TITLE: Balance Board		REV: 1.01
EasyEDA	Company: S/V Skylark	Sheet: 1/1
	Date: 2022-02-14 Drawn By: Steve Schroeder

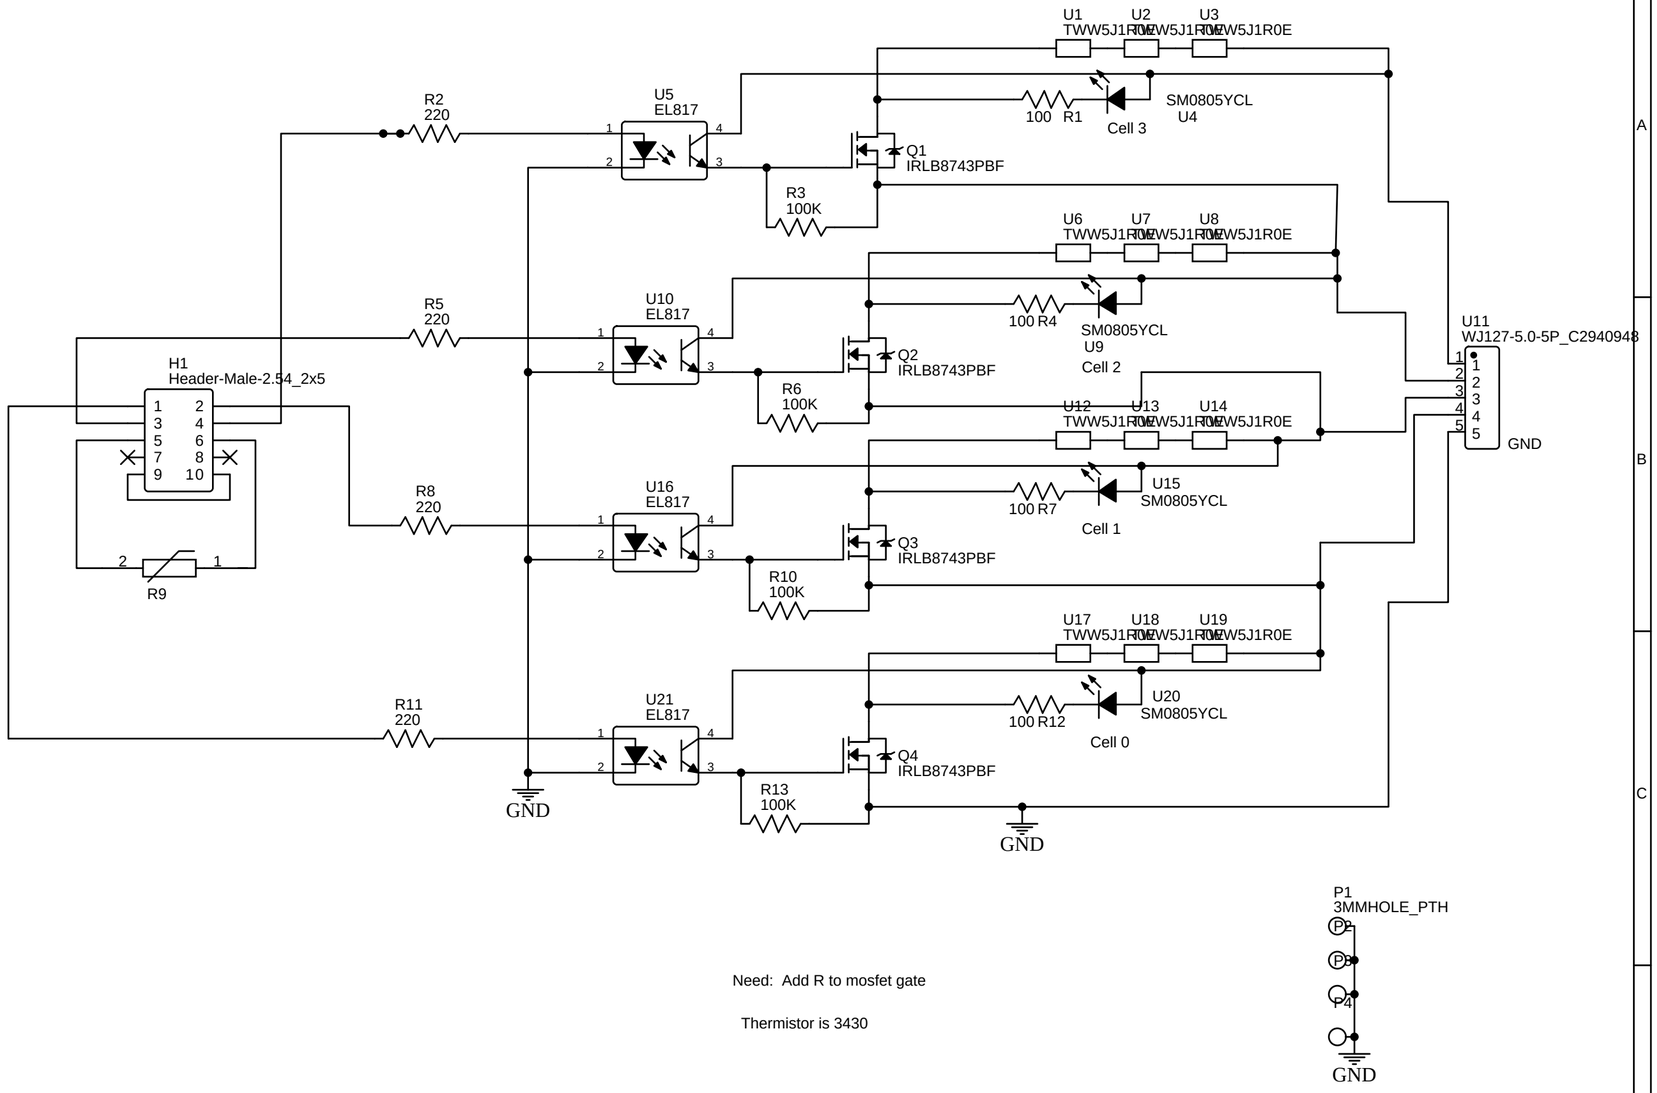
Need: Add R to mosfet gate

Thermistor is 3430

4/11/22 deleted unesasary battery connections
